**AGENDA**  
**Molalla Planning Commission**  
**6:30 PM, July 6, 2022**

- SDR04-2022 – 710 W Main ST – New Fueling Station and Convenience Store

<b>Date:</b>	June 29, 2022 for the July 6, 2022 Planning Commission Meeting
<b>File No.:</b>	Consolidated Review for SDR04-2022 and CUP02-2022
<b>Proposal:</b>	Construction of a New Fueling Station and Convenience Store
<b>Address:</b>	710 W Main ST (OR-211)
<b>Tax Lot:</b>	Taxlots 300 and 390 of Clackamas County Taxmap 52E08C
<b>Applicant:</b>	AKS Engineering and Forestry on behalf of Molalla Petroleum – Zach Pelz 3700 River RD N, STE 1 Keizer, Oregon 97303
<b>Property Owners:</b>	Donald Gary Bunnell and Marie Anne Bunnell, and successors, as Trustees of the Bunnell Family Trust 8751 Redcliff Place Riverside CA, 92508
<b>Applicable Standards:</b>	<b>Applicable Standards: Molalla Municipal Code, Title 17, Development Code</b>

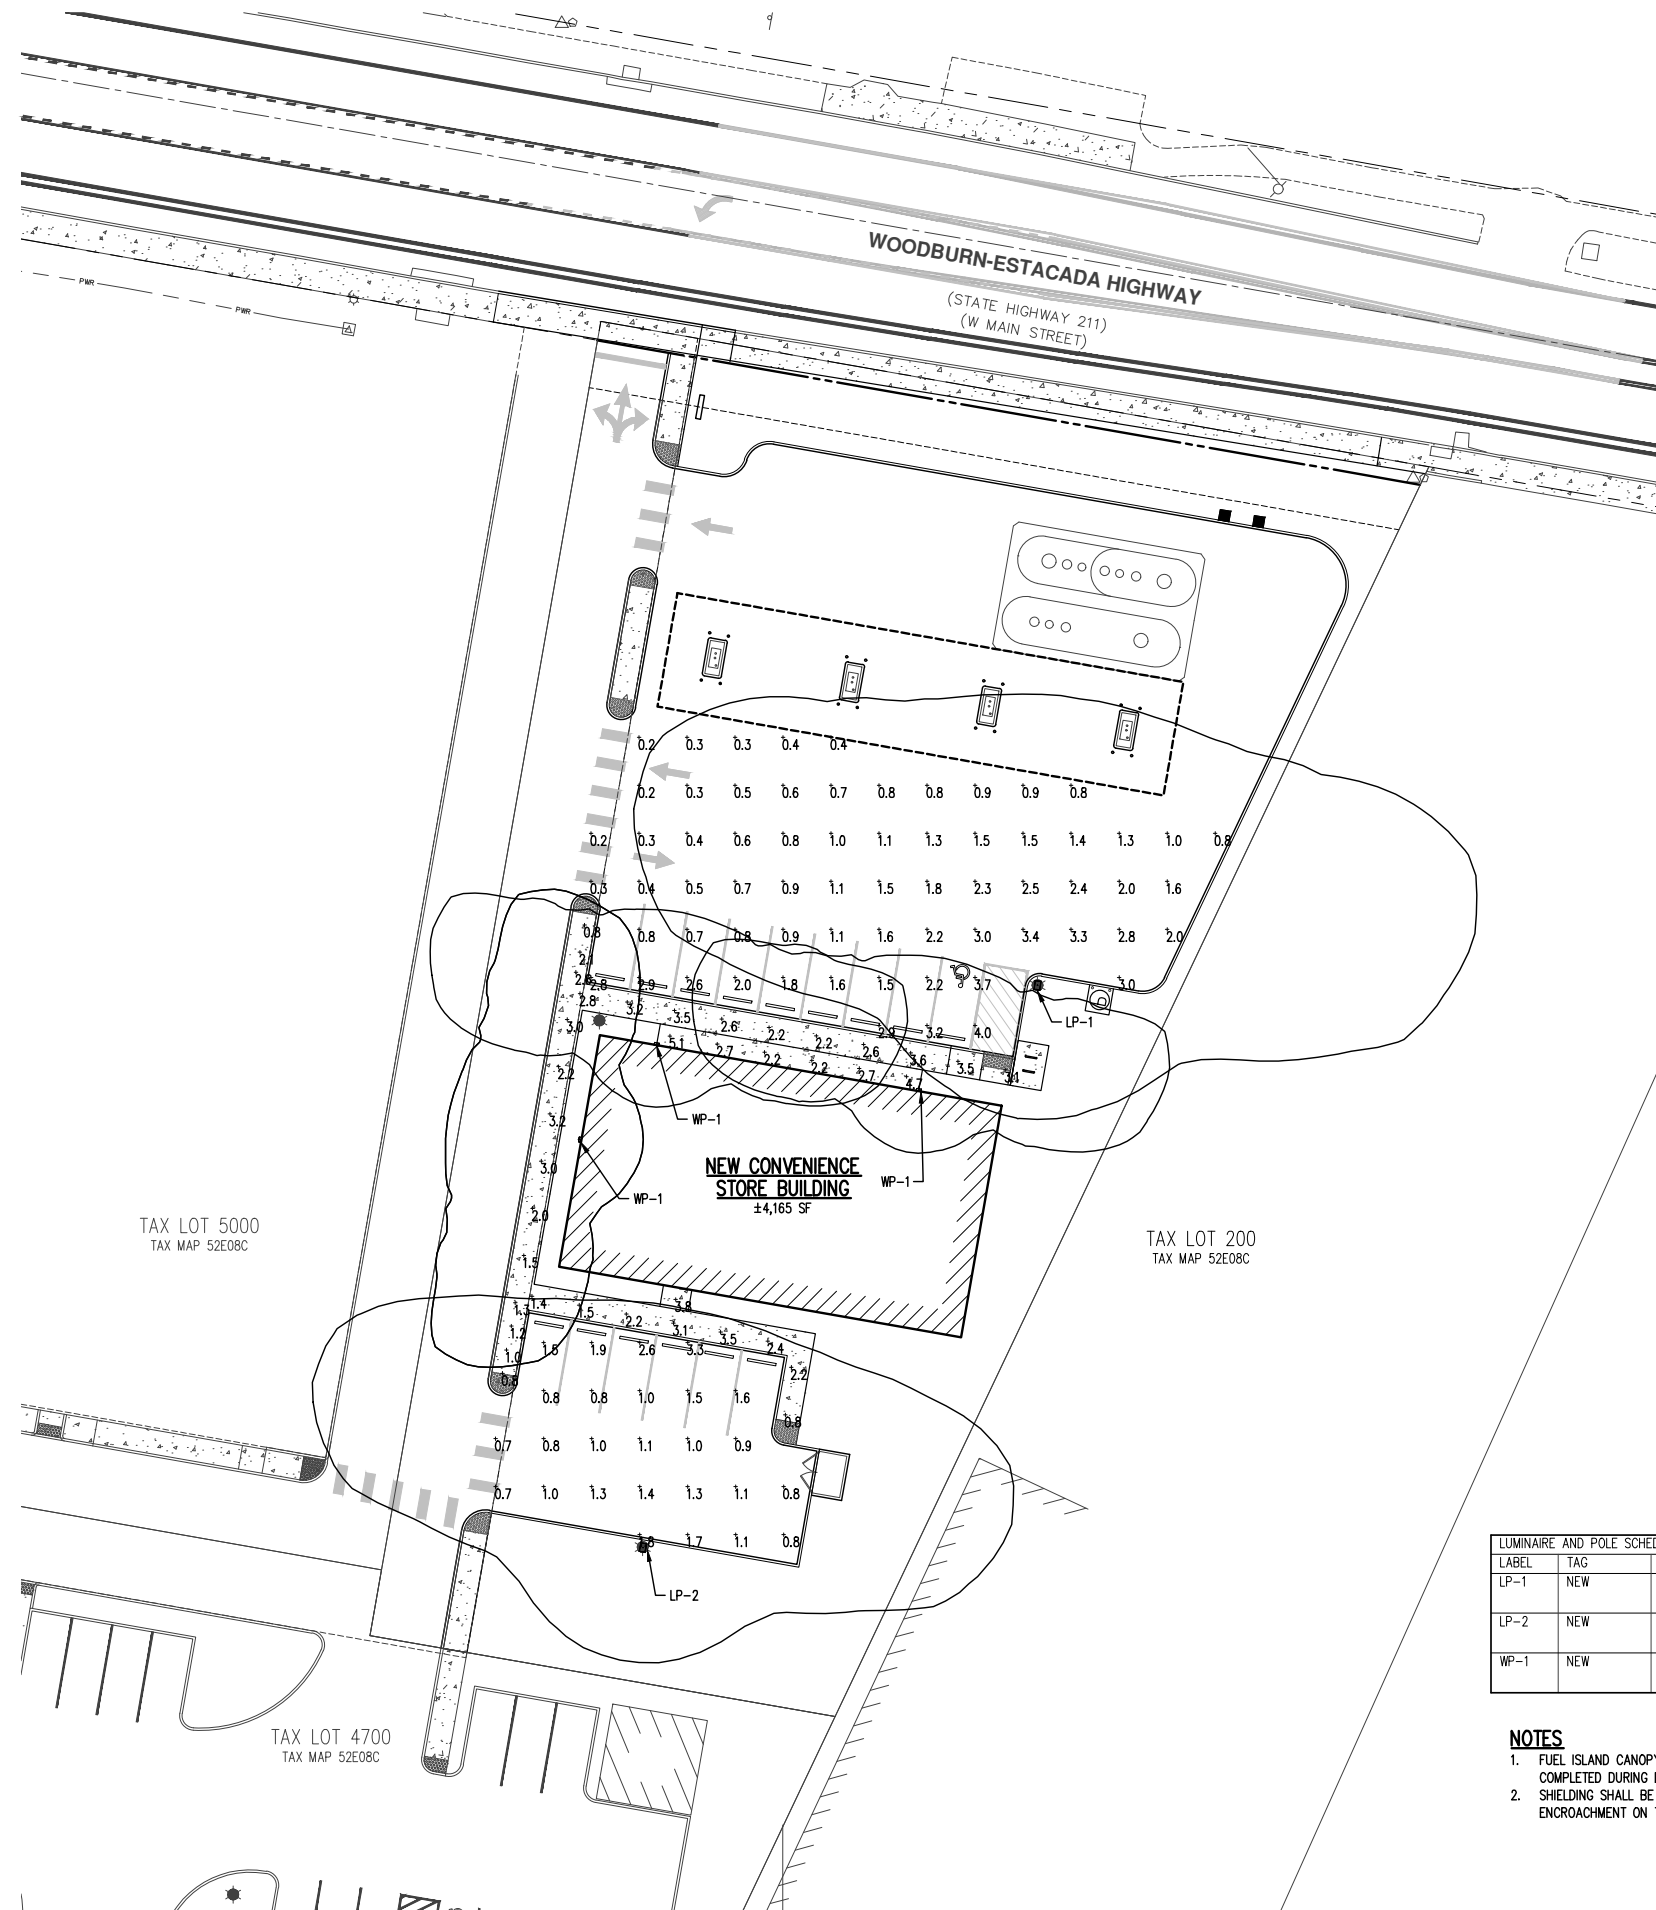
- c. The Applicant shall submit a revised lighting photometrics plan meeting standards and that incorporates the entire fueling station and associated drive aisles.

AKS DRAWING FILE: 9010 TRUCK TURNING.DWG | LAYOUT: P-10

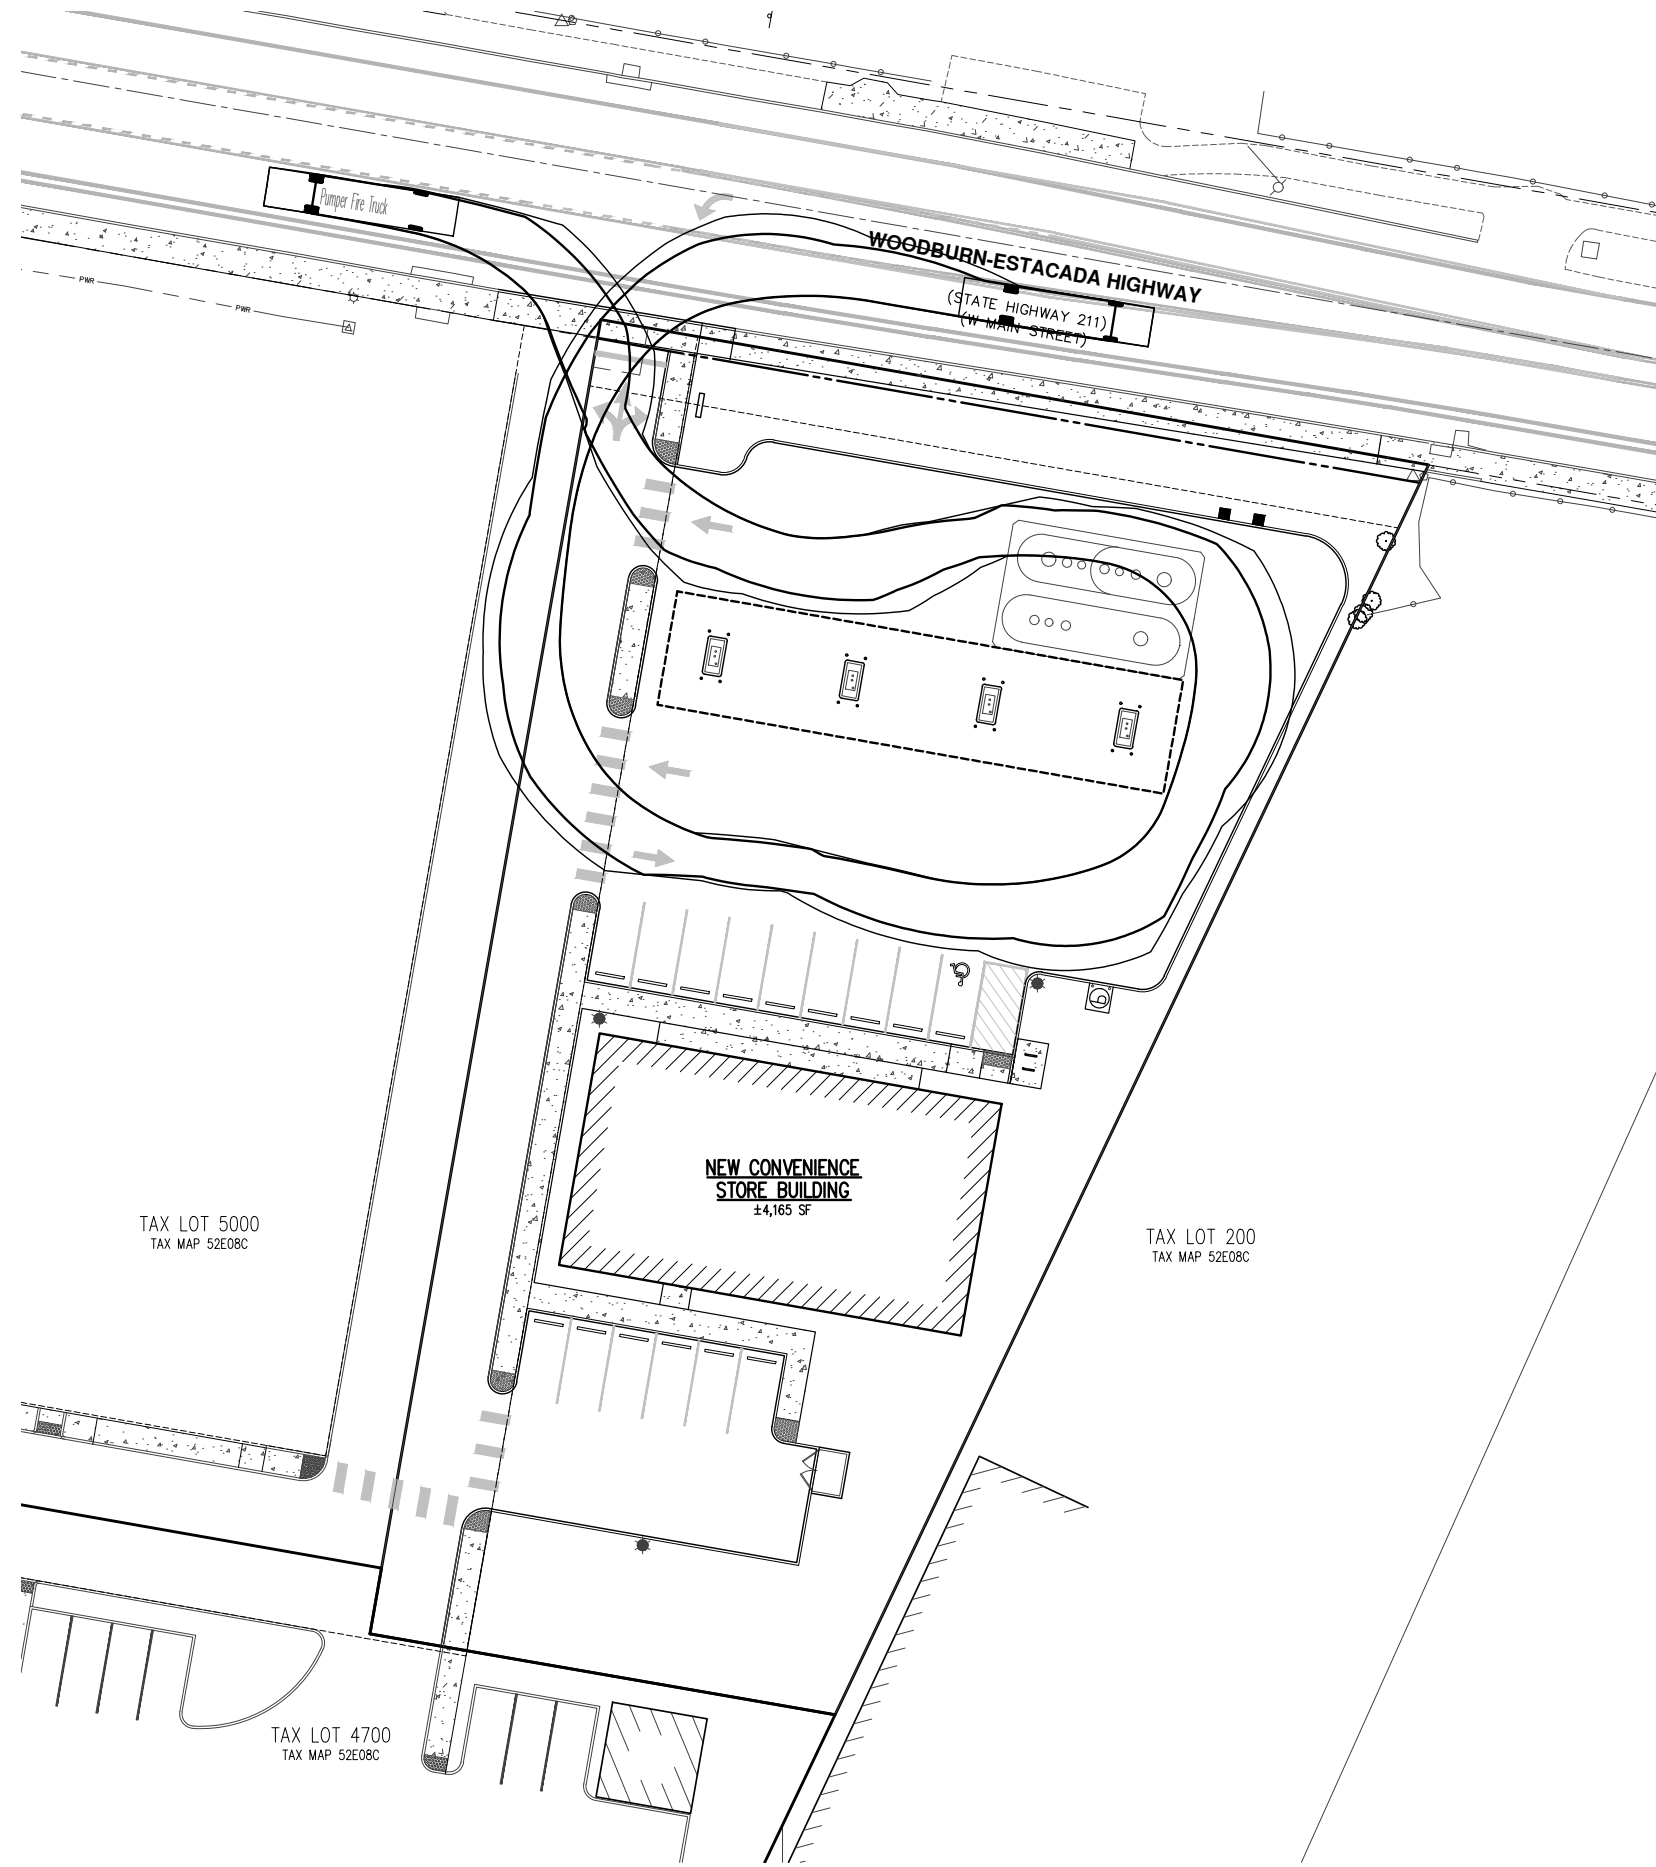
- IV. The Applicant shall submit a revised truck turning template plan with civil review plans showing truck turning radii for the largest proposed vehicle to enter the site to ensure the proposed approaches can accommodate that vehicle. This plan shall show turning motions from the appropriate lanes from the ROW in OR-211.
